Application by ROB COUCH for a PRELIMINARY SPECIAL TAX ASSESSMENT for HISTORIC PROPERTIES at 660 South Main Street (TM# 0070000302000)

**Planning Staff Report to
Design Review Board - Neighborhood
July 29, 2022
for the August 4, 2022 Meeting**

HISTORIC PRESERVATION CERTIFICATION APPLICATION
STATE HISTORIC PRESERVATION OFFICE
REVIEW & RECOMMENDATION SHEET
PART 2 / PART 3—REHABILITATION

660 S. MAIN STREET RENOVATIONS

A1
A502
LEVEL 1 ENLARGED FLOOR PLAN - EXTERIOR STAIR + ELEVATOR
3/8" = 1'-0"

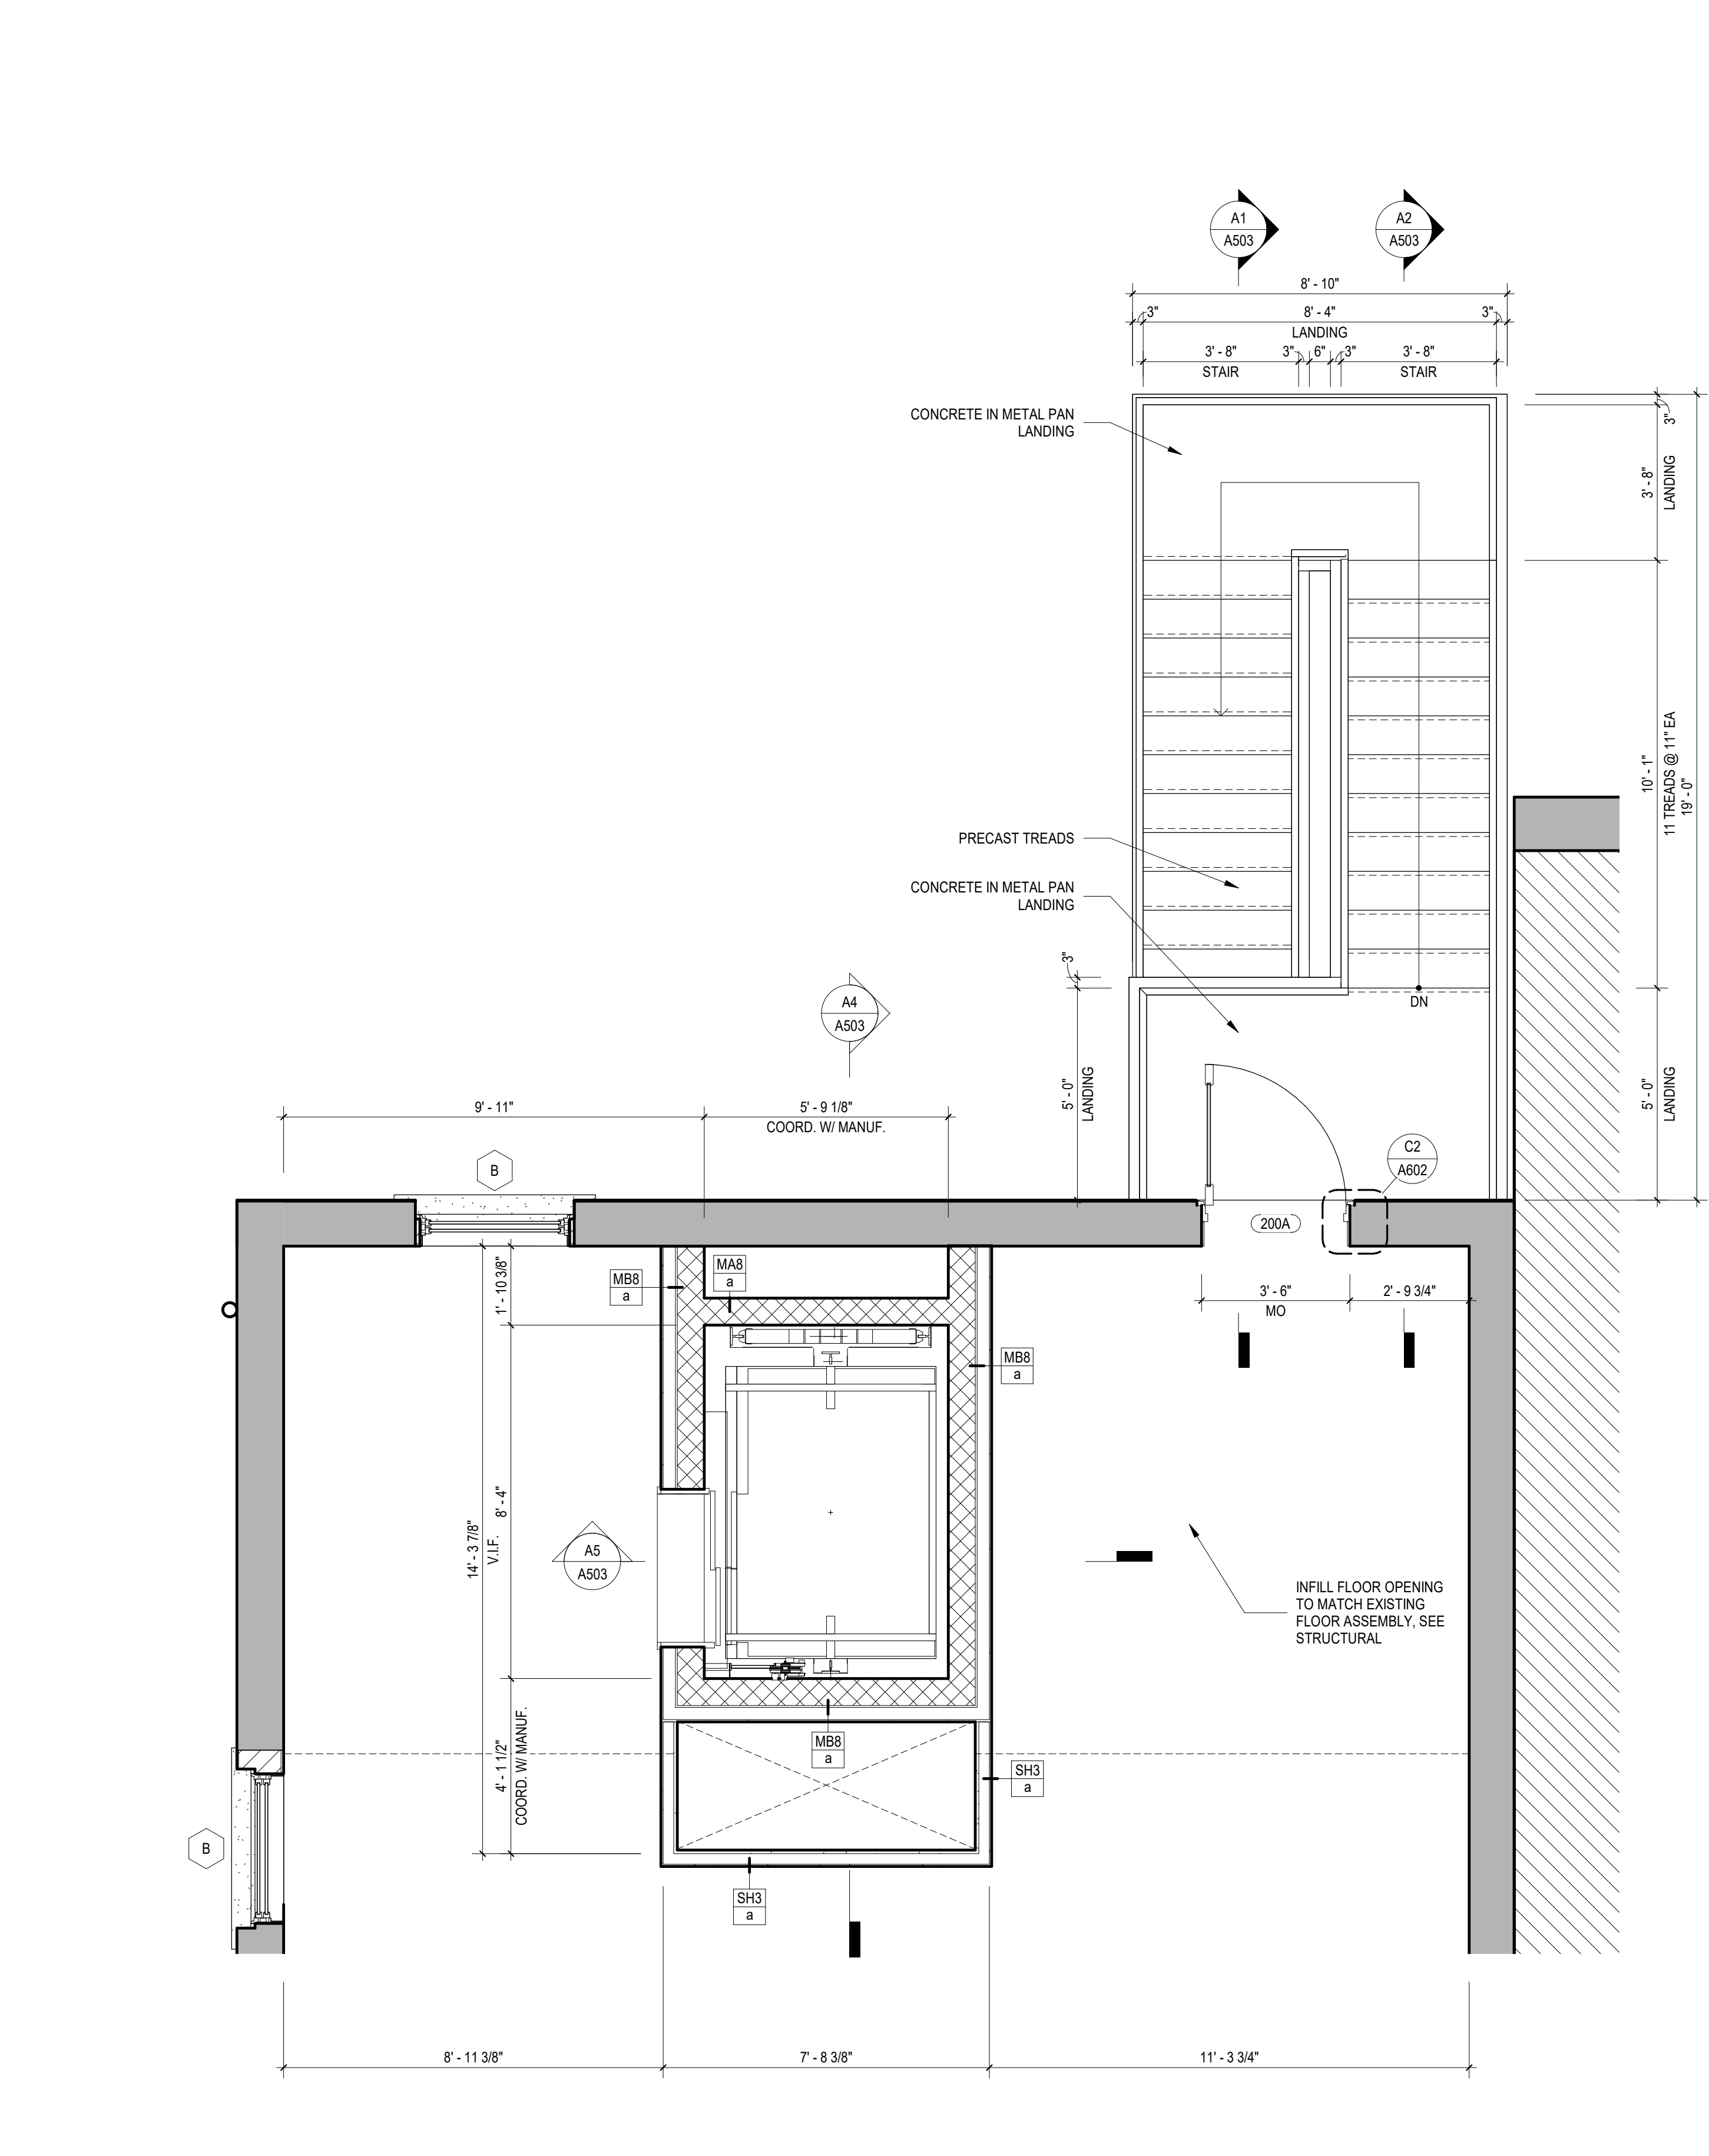
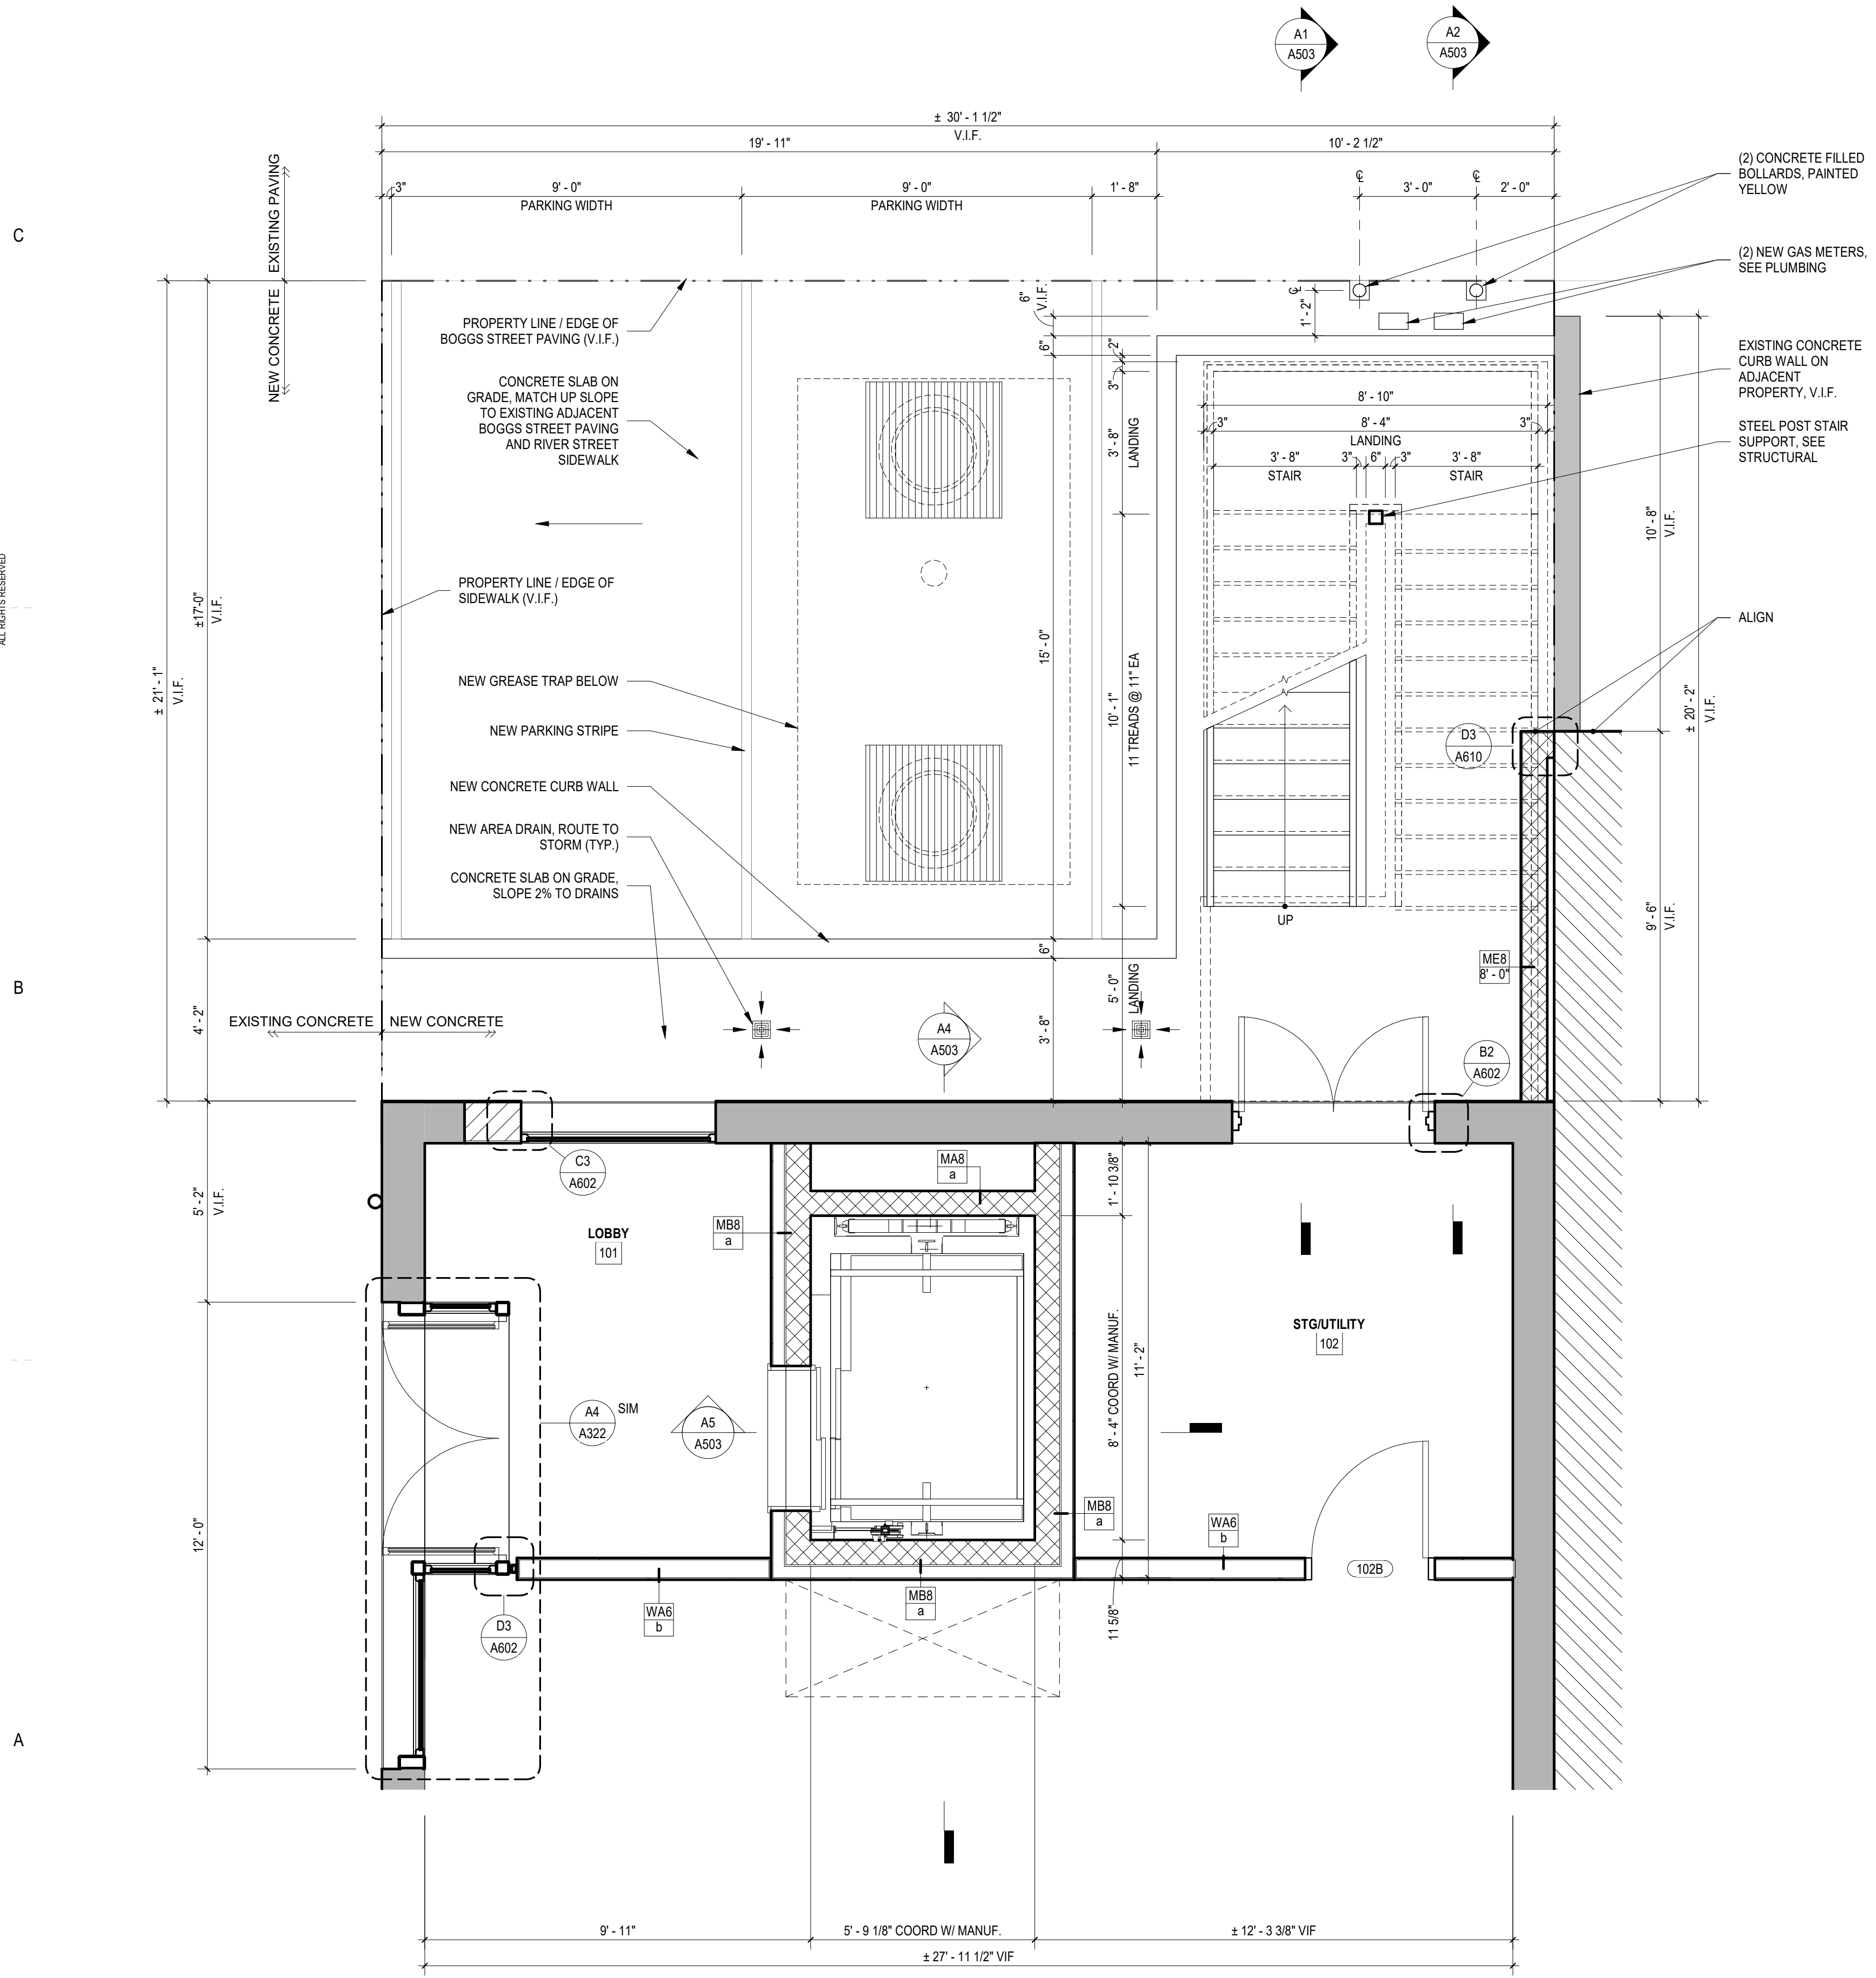
5. New rear stair - The proposed stair on the rear of the building is highly visible from the street, incompatible in design, and must be revised. The current design with the curved landing, splayed footprint, and perforated steel guardrail are too distinct and needs to be simplified. Any new stair in this location must be compatible with the design vocabulary of a historic fire stair. In order to ensure the stair meets the *Standards*, detailed dimensioned drawings of the proposed stair must be submitted for review.

This amendment provides revised descriptions and architectural drawings for the previously proposed rear staircase, windows, and storefront for this 20th century, two-story, masonry commercial structure. This amendment describes a compatible rear staircase that is set back from the street and public-right of way and that exhibits a simple railing and plan design. This amendment describes windows based on historic documentation and physical evidence that are compatible with the historic character of this building. This amendment describes a storefront that is compatible with the historic character of this building and that is based on historic documentation and physical evidence. The work described in this amendment related to the aforesaid rear staircase, windows, and storefront meets the Secretary of the Interior's Standards for Rehabilitation.
